UNITED STATES EPARTMENT OF THE II	NTERIOR C	OCD Artesia	OMB	NO. 1004-0135 es: July 31, 2010
BUREAU OF LAND MANAGEMENT SUNDRY NOTICES AND REPORTS ON WELLS Do not use this form for proposals to drill or to re-enter an abandoned well. Use form 3160-3 (APD) for such proposals.				5. Lease Serial No. NMNM12833

6. If Indian, Allotte	e or Tribe Name	
SUBMIT IN TRIPLICATE - Other instructions on reverse side.				7. If Unit or CA/Ag	greement, Name and/or No.
I. Type of Well ☐ Oil Well ☐ Other				8. Well Name and N ARROW ARW	No. FEDERAL COM 1

2. Name of Operator Contact: TINA HUERTA YATES PETROLEUM CORPORATIONE-Mail: tinah@yatespetroleum.com				9. API Well No. 30-015-28898	 }
3a. Address 105 SOUTH FOURTH STREE ARTESIA, NM 88210	3b. Phone No. (include Ph: 575-748-4168) Fx: 575-748-4585	·	10. Field and Pool, PENASCO; V

Yates Petroleum Corporation Arrow ARW Federal Com 1 API 3001528898, T19S-R25E, Sec 11

Wellbore schematics attached

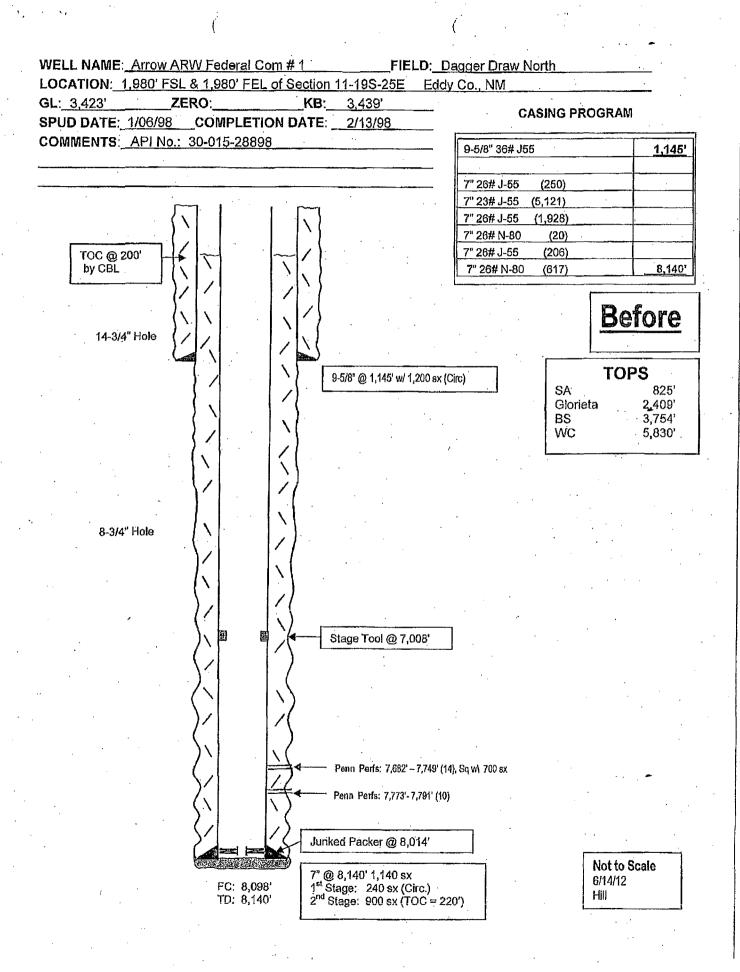
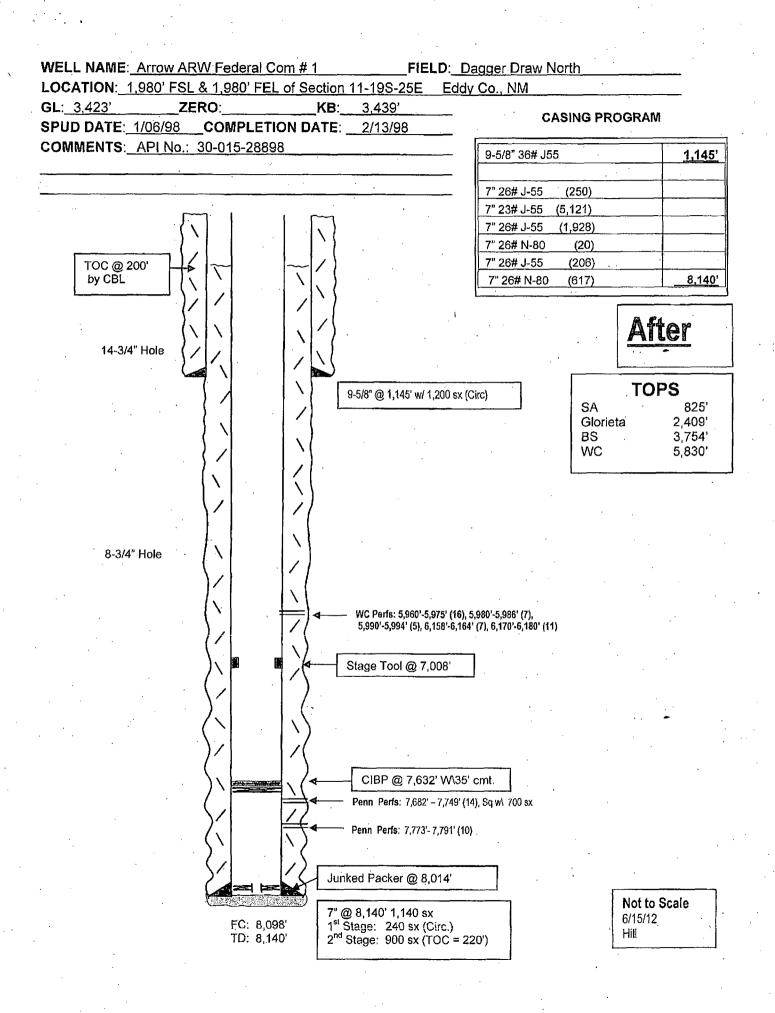
- 12. Step 3 Set a balanced (25sx minimum) Class "H" plug on the CIBP to be set at 7632. Tag this plug with tubing at 7452 or higher, covering the Canyon formation top.

- 14. Minimum requirement for mud placed between plugs is 25 sacks of salt water gel per 100 barrels in 9 lb/gal brine.
- 15. Cover the DV Tool (7008) with a balanced cement plug (25sx minimum) set at 7058. Tag this plug at 6942 or higher.
